PROJECT: GRK Corporate Hangar Phase II
AIP # 3-48-0361-050-2022

Change Order No. 002 makes the following changes, see attached for detailed terms of the change order.

Change Order 2: Narrative to Accompany 2nd Floor Stairwell and Finish Out Drawings

21A06081 - KFHR MAP II Hangar – Second Floor Finish-Out

HAZARD
CLASSIFICATION
PLAN - 2ND FLOOR

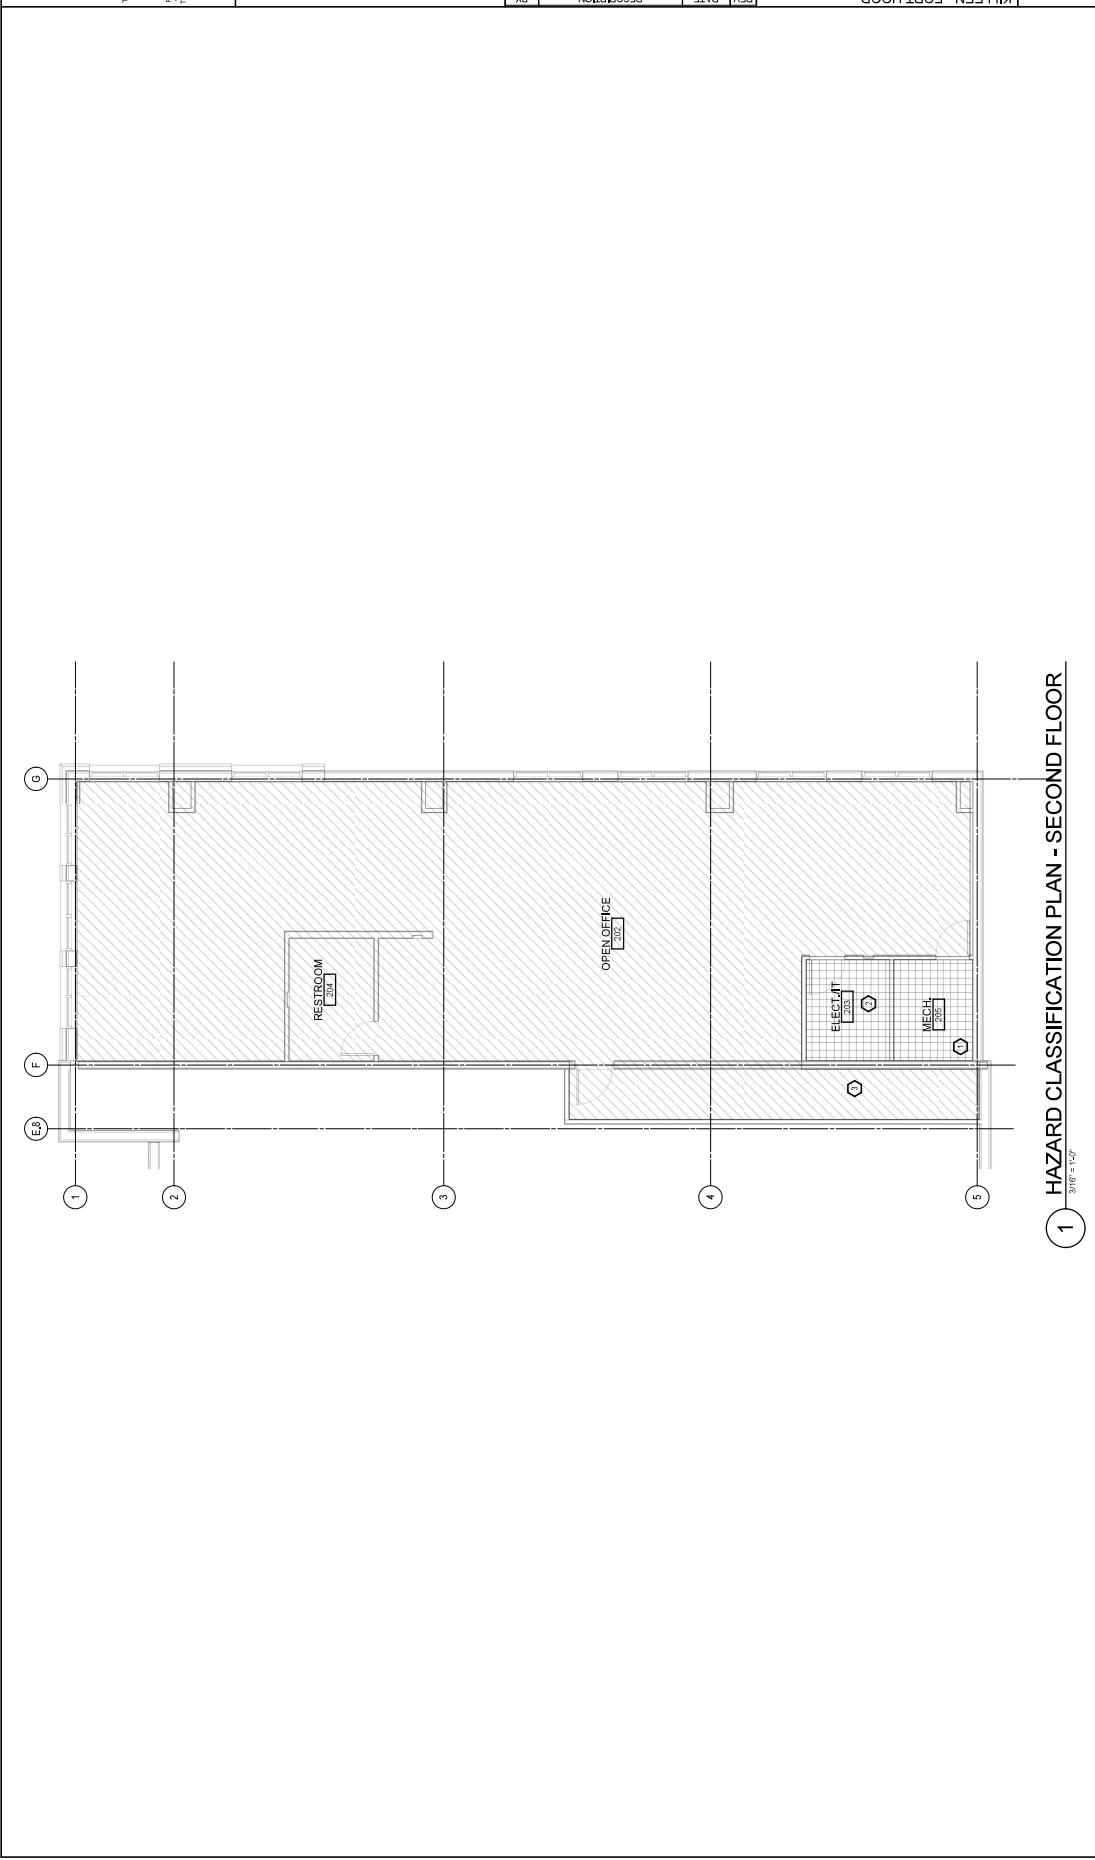
Fire sprinklers should be modified from upright heads at the ceiling deck to semi-recess heads at the drop ceiling.

Fire alarm devices will need to be added to provide coverage of the 2nd floor. It is estimated that 4x horn/strobes, a single strobe, and a single pull station be added.
